**Selkirk FPS  
(Flood Protection  
Scheme)**

**Formal review of feedback  
from Public Exhibition No. 2  
held on  
23<sup>rd</sup> and 24<sup>th</sup> May 2011**

1<sup>st</sup> July 2011

**Issue No : 02**

**APPENDIX B: Sketch to compliment response to questionnaire number 002**

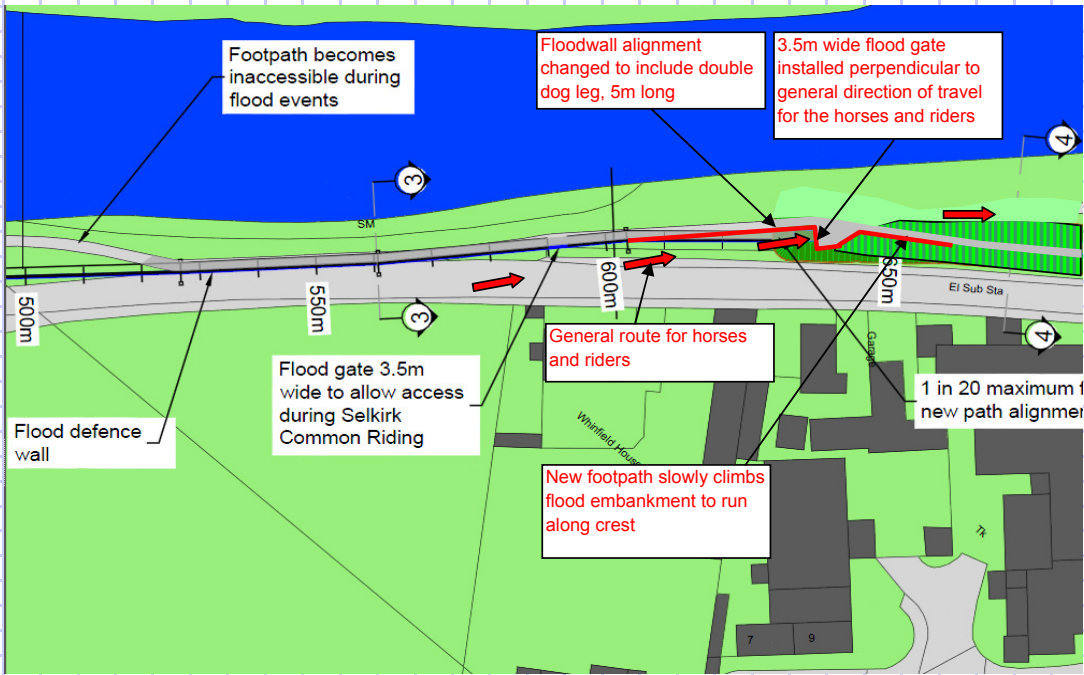
002	Selkirk Town	YES	YES	YES	YES	YES – access for common riding would safer using a ramp rather than the gates as shown on the plan	YES	YES	New crossing of the Long Philip Burn		In response to this and several other comments and discussions on this subject, the proposal for Common Riding Access has been changed to a flood gate which is provided within the wall and is perpendicular to the path the horses and riders take, rather than parallel. Refer to Sketch 1 in Appendix B of the report
003	Bannerfield Area	YES	YES	YES	YES	YES	YES	YES	Improved road safety around the Angles field		
004	Broadmeadows	UNANSWERED	UNANSWERED	UNANSWERED	UNANSWERED	UNANSWERED	UNANSWERED	UNANSWERED	UNANSWERED	<p>Pleased to see proposals to ameliorate flood problems in Selkirk are being progressed – congratulations. One of the principal flood risks in Selkirk comes from the Long Philip Burn. The hills where this rises are also the source for a number of burns which flow past Yarrowford and Broadmeadows. Heavy rain which causes the Long Philip Burn to surge creates the same effects on the burns which flow past Yarrowford and Broadmeadows. Hence, the major floods in Selkirk (e.g. 2003) were mirrored in major catastrophes in Yarrowford. I appreciate that Yarrowford is outwith the Selkirk flood prevention scheme, but action is needed as much at Yarrowford as at Selkirk. Options have been discussed but disappointingly nothing substantive has yet been done on the ground. Can SBC give a firm date as to when action will be implemented at Broadmeadows/Yarrowford to provide these communities with the same relief as is now being offered to Selkirk?</p>	<p>SBC undertook a study in early 2011 to determine the possible options for reducing the flood risk presented by the watercourses which flow through Broadmeadows and are culverted under properties and the A708 to discharge into the Yarrow Water. This study revealed that it is possible to create a high flow diversion route across to the Old Broadmeadows Burn via an existing channel.</p> <p>Progressing this project involved substantial discussions with SEPA and the obtaining of a CAR License. This license is now in place.</p> <p>The project's detailed design is complete and a contractor has been selected to undertake the works. At this point the Council are undertaking negotiations with the Landowners to gain access to the land.</p> <p>Construction of this work is expected to commence in August 2011.</p> <p>Additionally, as part of the Selkirk FPS, a range of Natural flood Management measures are being considered for the Long Philip Burn. Such measures could be similarly adopted on the various Broadmeadows watercourses catchments.</p>

Annotated version of original proposal presented at public exhibition shown below - annotations shown in red

- Surfacing of verge on approach to the gate to be confirmed through discussion
- Once through the gate, horses will be able to ride along the flat grassy area which replaces the route of the existing tarmac footpath.
- New footpath located on top of the flood defence embankment.
- Proposed gate is same width as existing gated access further downstream
